PLANNING COMMISSION
DATE: 11/13/19
AGENDA ITEM: 4B

ITEM: **Minor Subdivision – Inwood Addition (Inwood 7th Addition)**

Re: Inwood 7th Addition -Apartments
Preliminary Plan Review

TO: Planning Commission
FROM: Ken Roberts, Planning Director
AGENDA ITEM: **Preliminary Plat and Preliminary Planned Unit Development (PUD) Request - Lake Elmo Inwood Apartments (5th Street North)**
REVIEWED BY: Ben Prchal, City Planner

PRELIMINARY PLAT

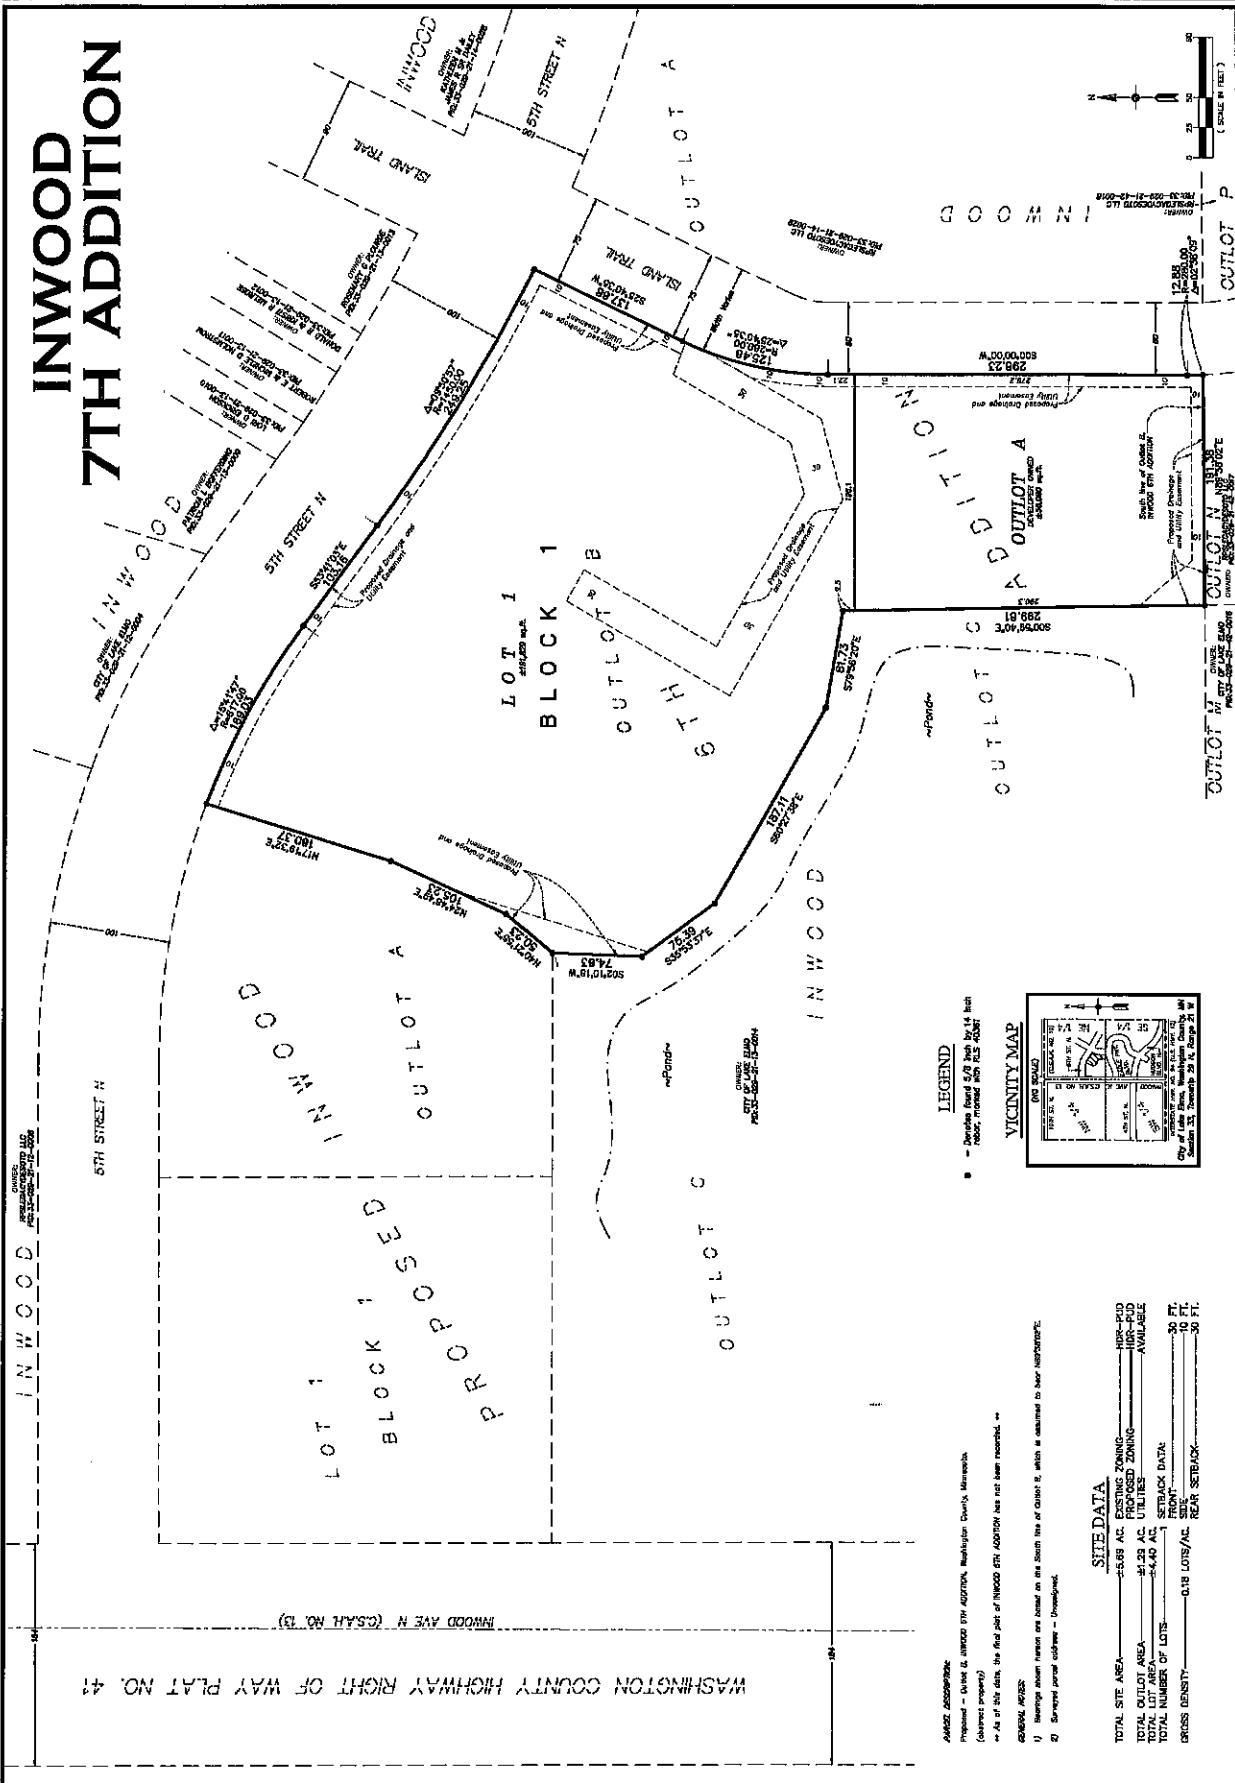
CITY ENGINEER REVIEW. I have attached the City Engineer's review comments (dated November 4, 2019) for your consideration. Items of note are as follows and I have included these as recommended conditions of approval.

- The Preliminary plat and project plans should be revised to show the proposed lot lines and easements consistent on each set of plans.
- Drainage and utility easements must be provided for any public utilities constructed as part of this project, including City-owned watermain and hydrants, with easements shown on the plat and on the project plans. Any watermain lines serving hydrants placed internal to the site require minimum 30-foot-wide easements centered over the hydrants and pipe. These easements must be dedicated to the City and be provided in the City's standard form of easement agreement.
- There were a number of other amendments required to the plan for approval, which can be reviewed in the memo. It is a recommended condition of approval that all of these comments be addressed on the plans before the applicant/developer submits a final plat for approval.

3. A 30-foot wide drainage and utility easement is shown as required for the public watermain and hydrants extended internal to the site. The preliminary/final plat easements must be revised and updated as necessary to accommodate any watermain/hydrant layout changes.

4. Consideration should be given to adjusting the south lot line of Lot 1, Block 1 further north to facilitate a shared commercial driveway access between Lot 1, Block 1 and Outlot A. See comment #2 below for Site Plans, Traffic and Access Management.

1. All required modifications to the plans as requested by the City Engineer in the review letter dated November 4, 2019 shall be incorporated into the plat and project plans. The City shall approve all plans before releasing the final plat for recording.

4. The final plat shall show a 10-foot-wide drainage and utility easement along all property lines.
5. All easements as requested by the City Engineer and Public Works Department shall be documented on the Final Plat before the execution of the final plat by City Officials.

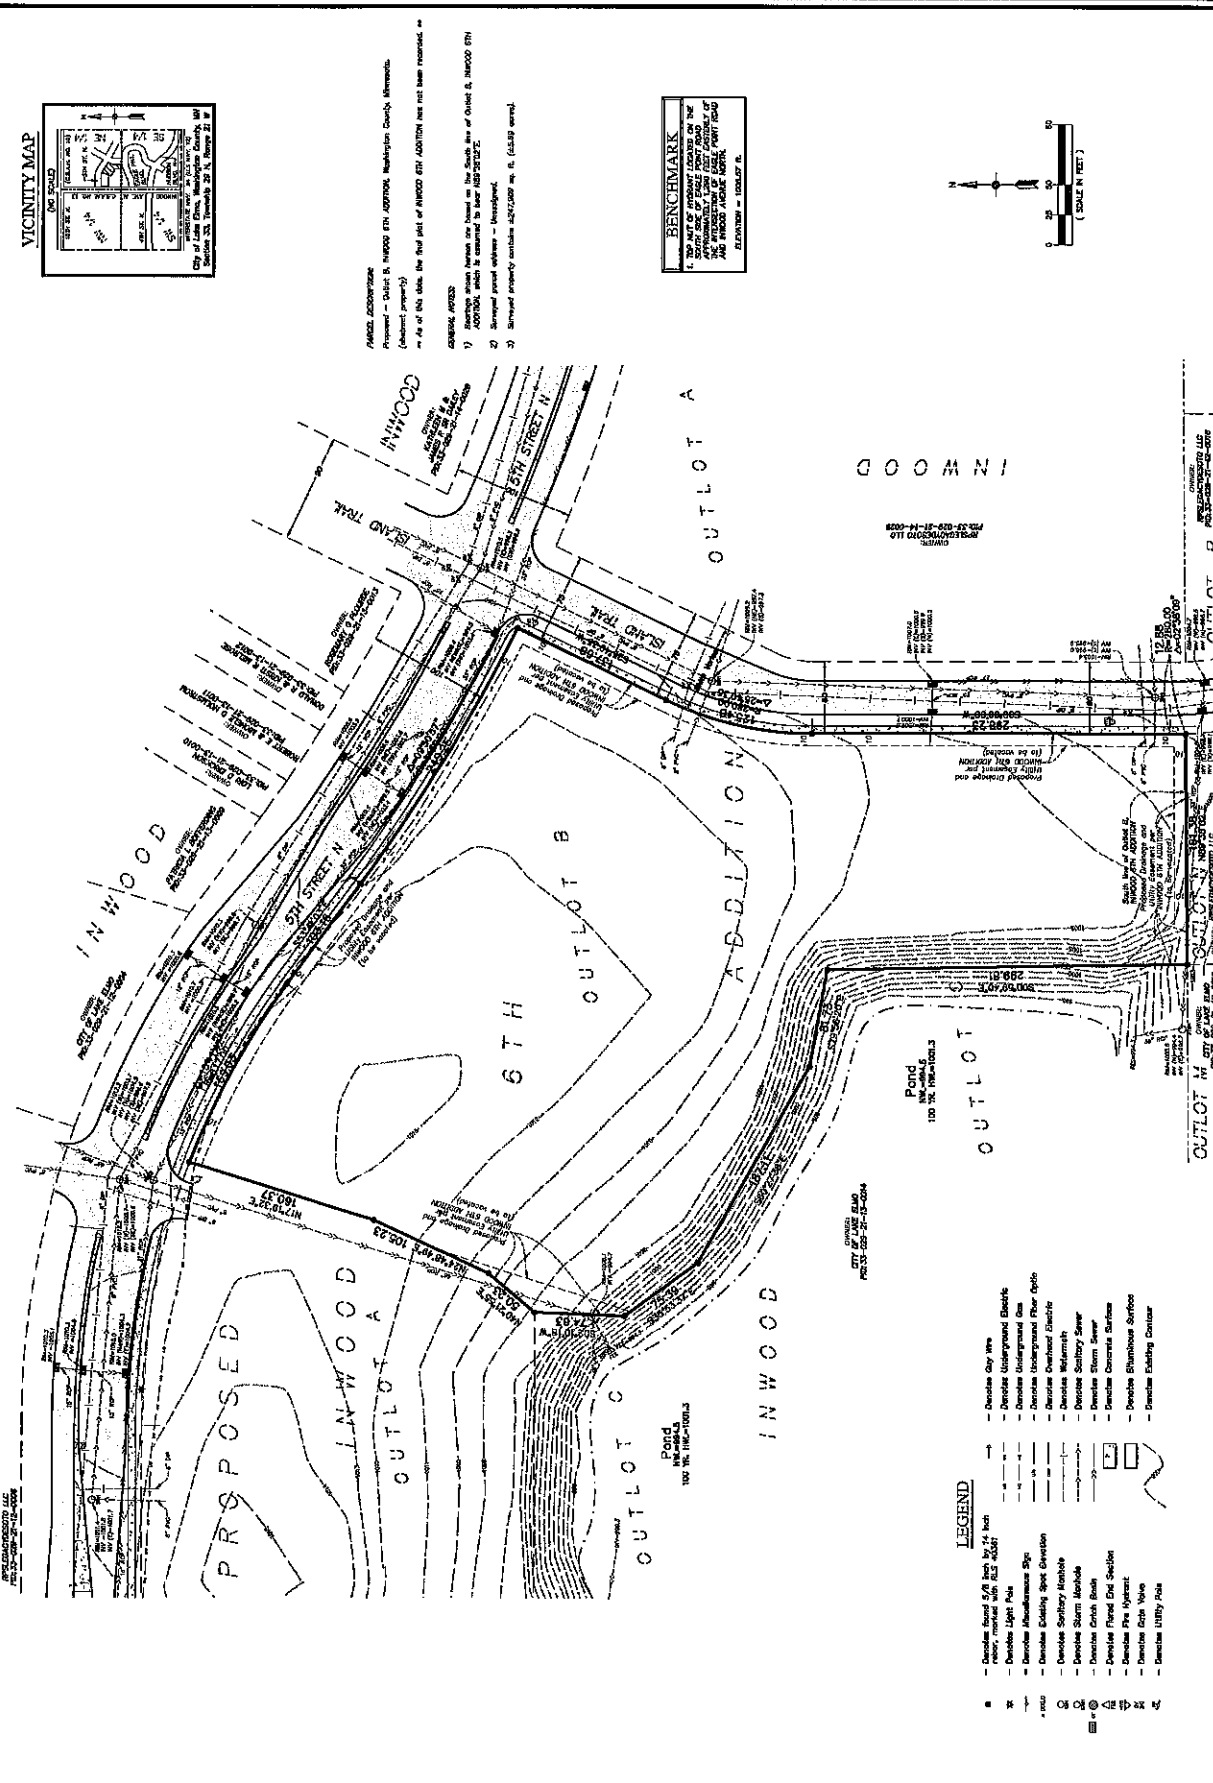
5. The site plans must be revised to address Fire Code requirements for emergency access roads. Access roads must be identified with signage and markings. Aerial Fire Apparatus Access Roads must be a minimum of 26-feet wide.

- The preliminary plans must be revised to maintain all tree planting outside of the front, side and rear drainage and utility easements.
- Consideration should be given to adjusting the south lot line of Lot 1, Block 1 further north to facilitate a shared commercial driveway access between Lot 1, Block 1 and Outlot A. (See note below about access from Island Trail).

- The site plans must be revised to address Fire code requirements for emergency access roads. All access roads must be identified with signage and markings. Aerial Fire Apparatus Access Roads must be a minimum of 26-feet wide.

- The proposed site access from Island trail must be designed as a shared driveway access for both Lot 1, Block 1 and Outlot A, Inwood 7th Addition (to the south), in order to allow for two potential access, as may be required by the fire code, for future development of Outlot A; or an alternative access plan for both properties must be submitted for review and approval by the City.

- Redesigning the site access to Island Trail to allow it to be a shared access with Outlot A to the south of the development site.
 - Revising the site and driveway plans to meet Fire code requirements for emergency access roads. Aerial access roads must be a minimum of 26-feet wide.

Ken Roberts
Planning Director
City of Lake Elmo
October 30, 2019

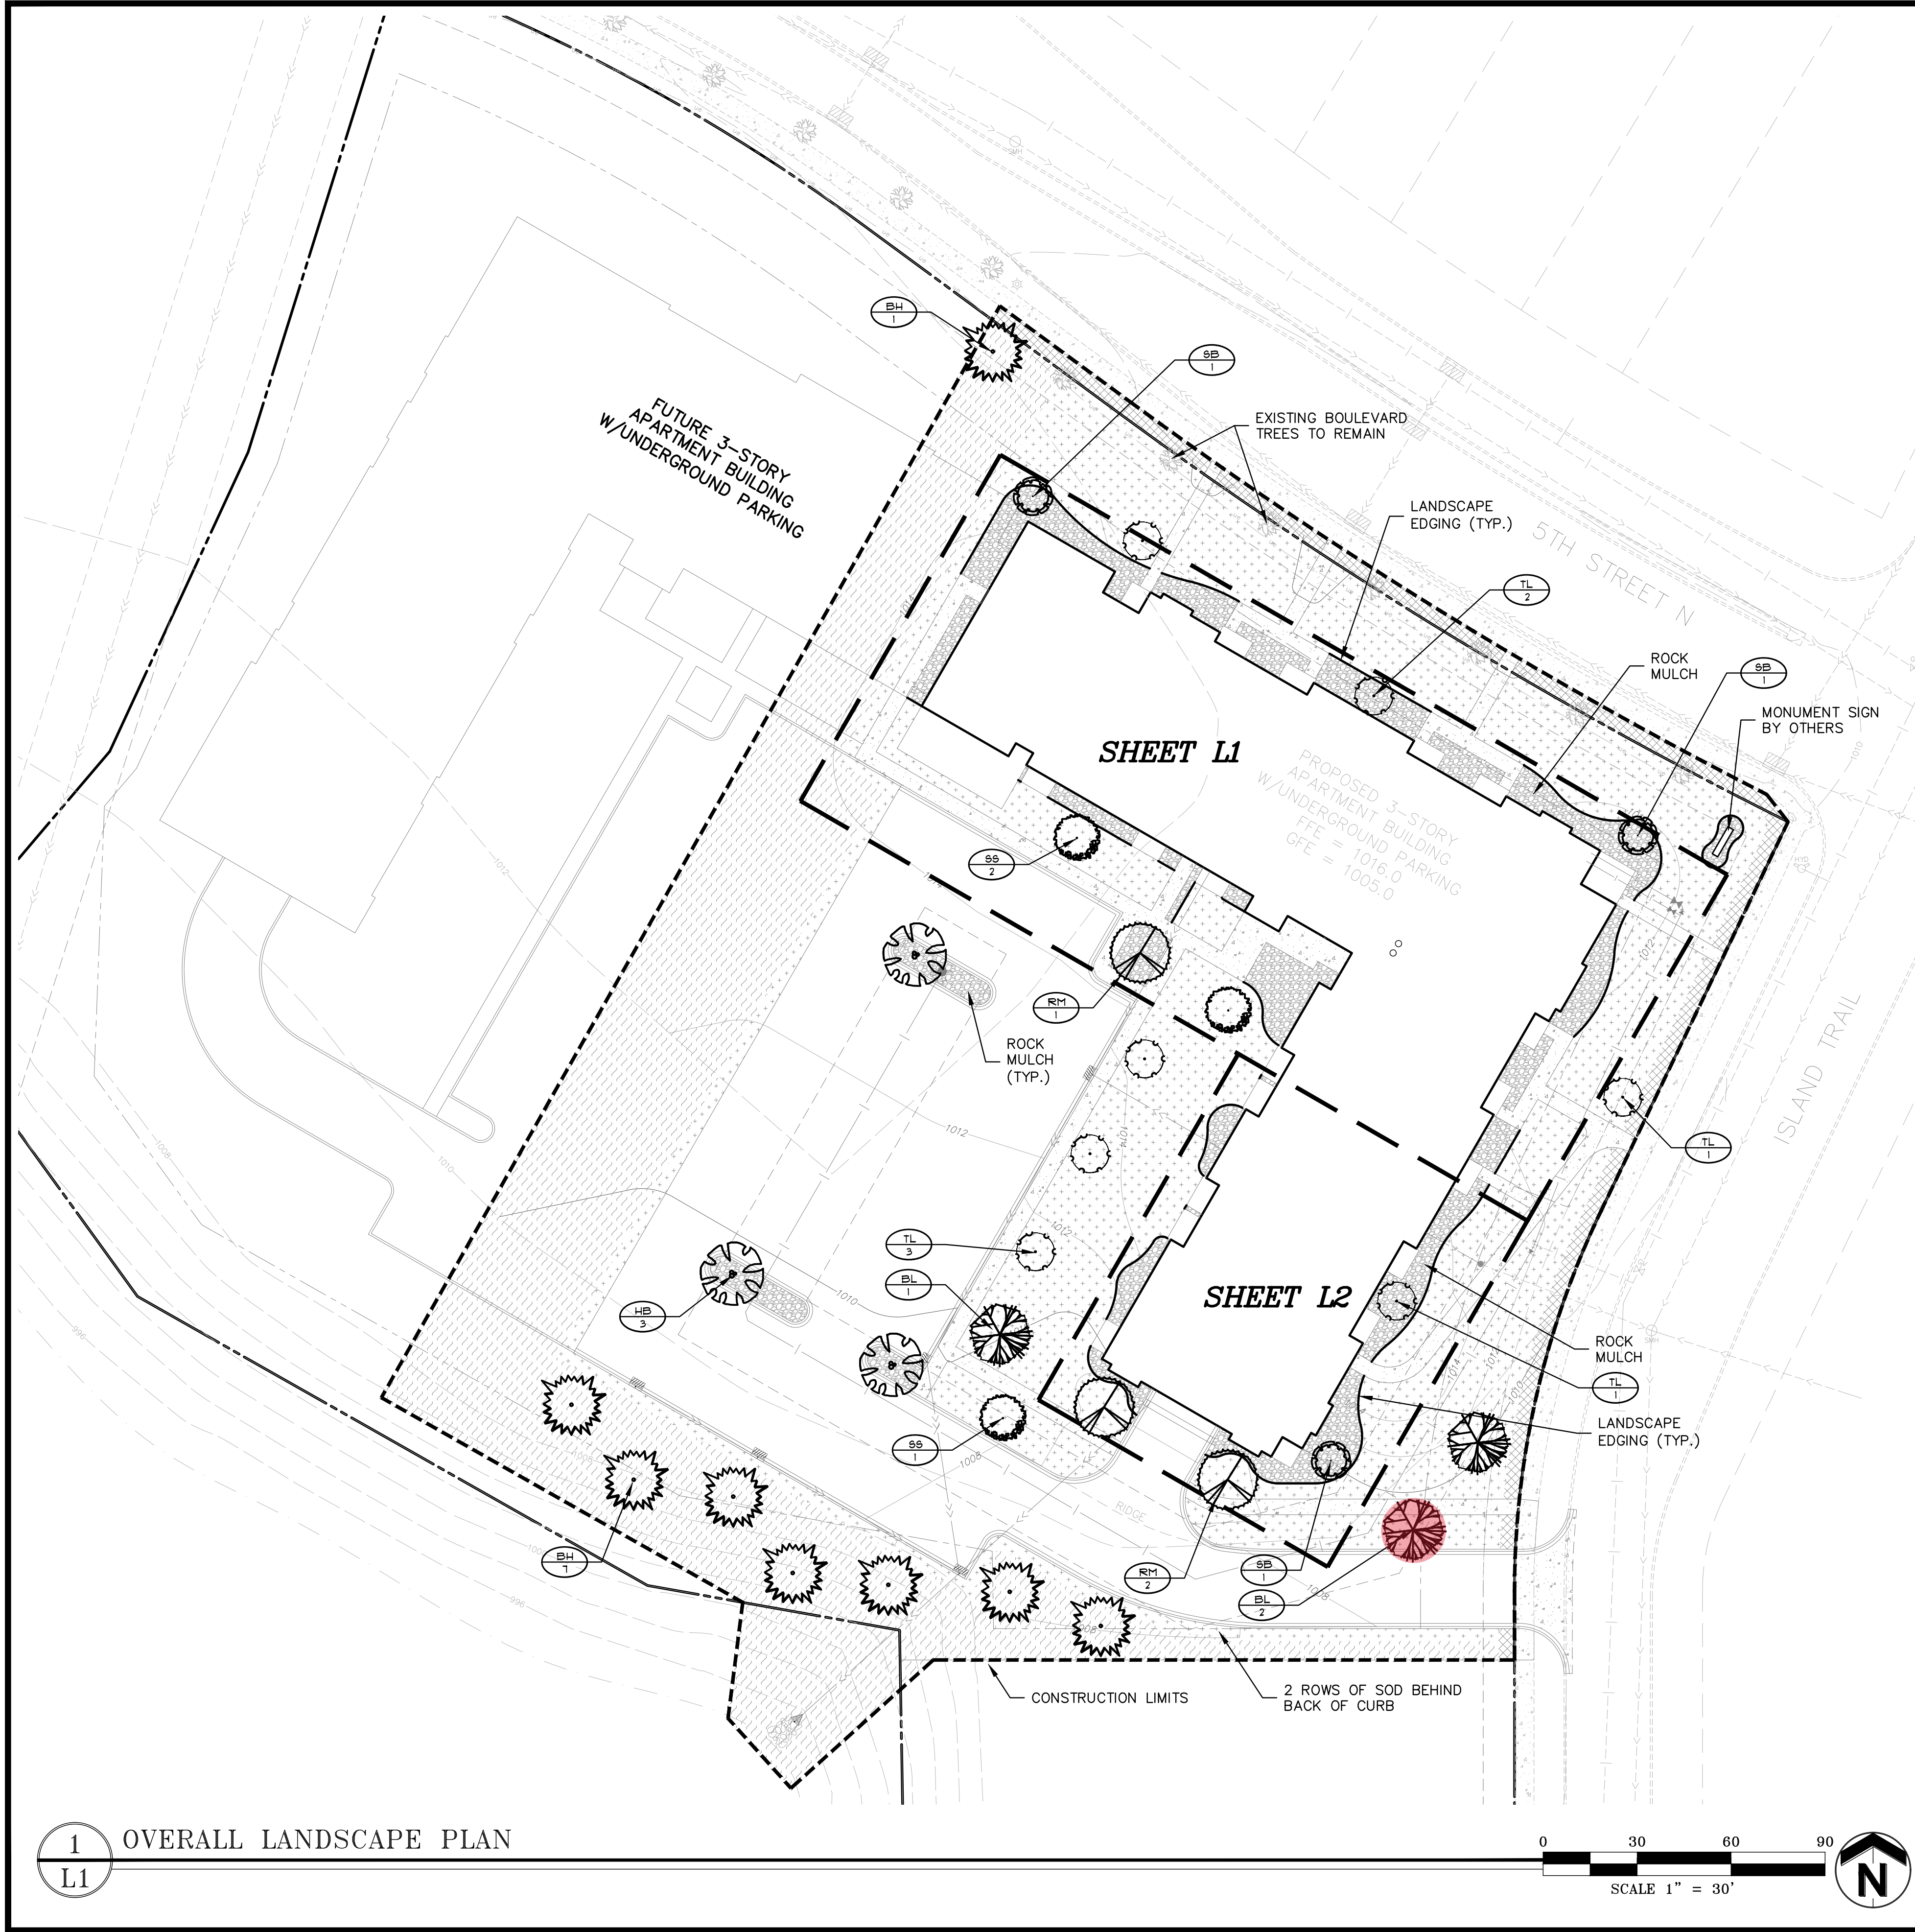
He noted that the proposed plans show the planting of not enough trees (30 proposed, 33 required) and that the proposed mix of trees does not meet code requirements. As proposed, there would be too many ornamental trees planted as a percentage (43 percent proposed, 15 percent maximum) of the total number of trees. The City should require the applicant to revise the landscape plans to meet or exceed the City's requirements before submitting plans for final PUD approval for this phase of the development. All tree planting and landscape plans will subject to review and approval by the City's Landscape Architect before the City releases or approves a grading or building permit for this development.

1. Submit a revised landscape plan addressing the above findings.
